Fort Calhoun Station (FCS), Unit 1
Renewed Facility Operating License No. DPR-40
NRC Docket No. 50-285

Subject: Response to FORT CALHOUN STATION, UNIT NO. 1 – REVIEW OF LICENSE AMENDMENT REQUEST TO ADD LICENSE CONDITION TO INCLUDE LICENSE TERMINATION PLAN REQUIREMENTS – 2nd REQUEST FOR ADDITIONAL INFORMATION (EPID L-2021-LIT-0000) JUNE 2, 2023.

**ATTACHMENT 1
FORT CALHOUN LICENSE TERMINATION PLAN REVIEW
REQUEST FOR ADDITIONAL INFORMATION FOR THE TECHNICAL EVALUATION
OMAHA PUBLIC POWER DISTRICT
FORT CALHOUN STATION UNIT NO. 1
DOCKET NO. 50-285, 72-054**

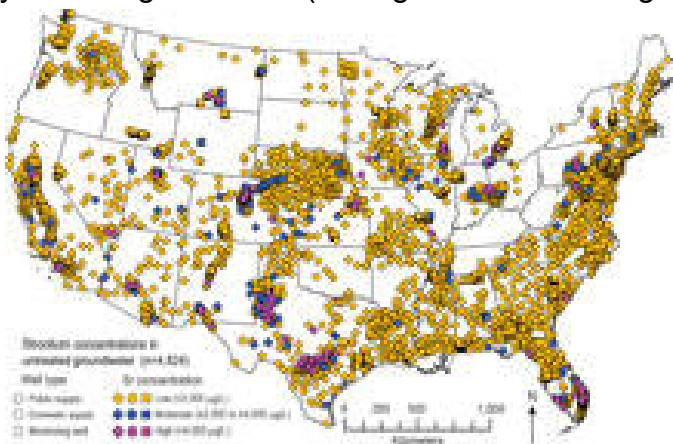
Comment: *Data for existing Sr-90 groundwater contamination does not support use of existing monitoring well data locations as the sole basis for estimating the maximum groundwater Sr-90 at the site to be used for the Final Status Survey (FSS) dose calculation.*

Basis: *LTP Section 2.4.2 summarized Sr-90 results for the groundwater during the period 2011 through 2018 as sporadic and low. However, staff review of Sr-90 data in FCS Annual Radiological Effluent Release Reports (ARERR) for 2007 through 2021 reveals a persistent, but sporadic, presence at different wells in and surrounding the DA. The continued presence of Sr-90 residual radioactivity in the groundwater indicates a persistent source that has not shown signs of abating. Staff identified 65 Sr-90 results above the lower limit of detection (LLD) for the period 2007 through 2021. Two elevated Sr-90 results were also found in deep wells. Staff also assessed the Sr-90 results for the period 2011 through 2018, which was the period used for the summary provided in LTP Section 2.4.2 and found 36 results above LLD. Assessment of these Sr-90 values do not support a decreasing trend in Sr-90 over time. In addition, staff also notes that uncertainty and LLD were not provided with the ARERR Table III.9 groundwater results.*

The uncertainty may reflect on estimates of maximum Sr-90 activity needed for the FSS dose calculation.

There are several factors that influence the estimate of maximum Sr-90 groundwater concentration at the site. The source area for the Sr-90 contamination within the protected area is not known. Modeling to narrow possible source areas will be complex due to historical groundwater gradients influenced by onsite well pumping, flux of groundwater into the Turbine Building sump, and significant river stage changes occurring during water level measurement. Staff assessment of the historical groundwater data indicated gradients approximately equally divided between plant-west (inland), mounded under the site, and plant-east (towards the river). There is a broad area in the footprint of the plant and towards the river that is not covered by monitoring wells, i.e., the important zone between wells MW-7 and MW-6. Also, the possibility of a source area affected by rising and falling river stage cannot be discounted based on available hydrologic data and sporadic Sr-90 results. Full evaluation of Sr-90 in groundwater is needed to complete the site characterization required by 10 CFR 50.82(a)(9)(ii).

Request: *Provide an estimate of the maximum Sr-90 in the groundwater for the entire site that includes the area below the structures within the DA where the maximum contamination is expected to occur.*

The conditions mentioned in the basis are the reason there is not any more extensive Sr-90 investigation planned. From the historical data, there have been four samples total that have been above minimum detectable activity (MDA); the rest have been between 2-sigma error and MDA. The uncertainty and LLD are not included in the table of results in the annual reports because the system does not allow posting of negative values or characters that would indicate a non-detect. The procedure for LLD from the testing lab has been provided to the NRC for their information and review. The responsible group on-site maintains the raw data. The level of uncertainty is typically high due to the high levels of naturally occurring strontium (see figure from USGS.gov, January 2021)) in the water in Nebraska (the 2-sigma uncertainty was 0.545 pCi/L in the most recent round of sampling and the baseline sample was approximately 0.3 pCi/L). There are low-level amounts (greater than 2-sigma from the mean) that sporadically appear at or around the same levels that were identified prior to operation at Fort Calhoun Station

(FCS). The groundwater monitoring program continues to identify these statistical detects which, by NEI guidance, are reviewed for further investigation by the groundwater program owner. Given the persistent and static presentation of Sr-90 in the wells, the Groundwater program owner has not identified a plume or a source of any leaks that indicate a plant condition that could result in such detects. Because these identifications are sporadic in nature, i.e., no one well has shown a history of consistent detects; occur within the statistical margin of error for detection; and have occurred in groundwater wells upgradient from the operational areas of the plant, no further analysis has been justified. This data had been included in previous annual reports to support this conclusion for eventual decommissioning.
